**PLANNED UNIT DEVELOPMENT
& SUBDIVISION STAFF REPORT**

DEVELOPMENT NAME Carriage Towne Subdivision

LOCATION 6360 Cottage Hill Road
(North side of Cottage Hill Road, 170'+ East of Hillcrest Road and East side of Hillcrest Road, 174'+ South of Christopher Drive, and extending to the South terminus of Hillcrest Service Road)

CONTEMPLATED USE 2-lot Subdivision and Planned Unit Development Approval to allow shared access and parking between multiple building sites.

SITE PLAN

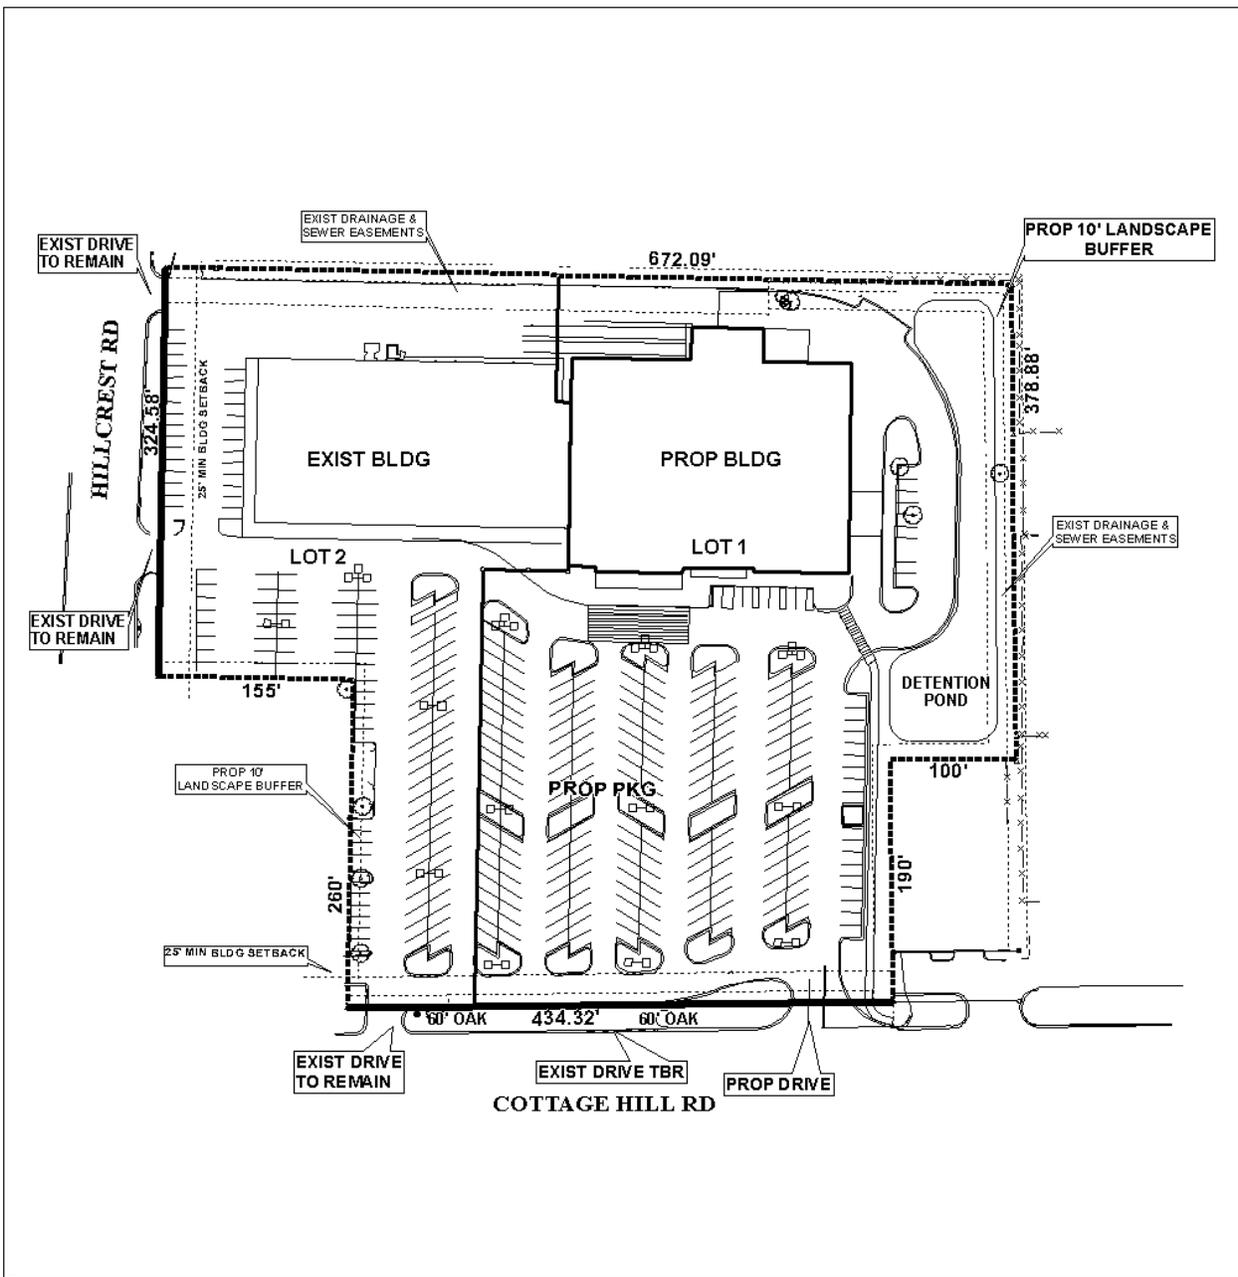
**ENGINEERING
COMMENTS** No storm water can cross lot lines without a hold harmless agreement. Verify that the ditch accepts public water, for it to be tied to. Analyze the capacity of the receiving stream. Must comply with all storm water and flood control ordinances. Any work performed in the right of way will require a right of way permit.

**TRAFFIC ENGINEERING
COMMENTS** Driveway number, size, location, and design to be approved by Traffic Engineering and conform to AASHTO standards. Traffic Engineering will require a traffic impact study to include the intersection of Cottage Hill Road and Hillcrest Road.

It should be noted that the proposed development has two existing curb-cuts onto Hillcrest Road and two existing curb cuts to Cottage Hill Road. As stated previously the only curb cut affected would be the easternmost curb cut to Cottage Hill Road; however, the size, location and design this curb-cut must be approved by Traffic Engineering and conform to AASHTO standards.

Properties to the North and East are zoned R-1, Single-Family Residential, and as such a 10-foot buffer strip and a 6-foot privacy fence, in conformance with Section 64-4.D. of the Zoning Ordinance, are required on the site in question.

Whereas the Landscape Plan does not illustrate the total and frontage landscaping square footage percentage, full compliance on Lot 1 would be required. The accompanying Tree Plan exceeds the required number of trees for the entire development.

RECOMMENDATION: **Planned Unit Development:** Based on the preceding, the PUD application is recommended for Approval, subject to the following conditions: 1) completion of the subdivision process; 2) provision of the required buffer fence where the site abuts residentially zoned properties; 3) any significant changes to the site development will necessitate approval of an amended PUD by the Planning Commission, to include all properties involved/affected; 4) Full compliance with landscaping and tree requirements for Lot 1; and 4) full compliance with all municipal codes and ordinances, including but not limited to sign number, location and size.

Subdivision: Based on the preceding, the plat is recommended for Tentative Approval, subject to the following conditions: 1) placement of a note on the final plat stating that Lots 1 and 2 are limited to the existing curb-cuts, with the size, design and location of the curb-cut to be approved by Traffic Engineering and conform to AASHTO standards; and 2) full compliance with all other municipal codes and ordinances.
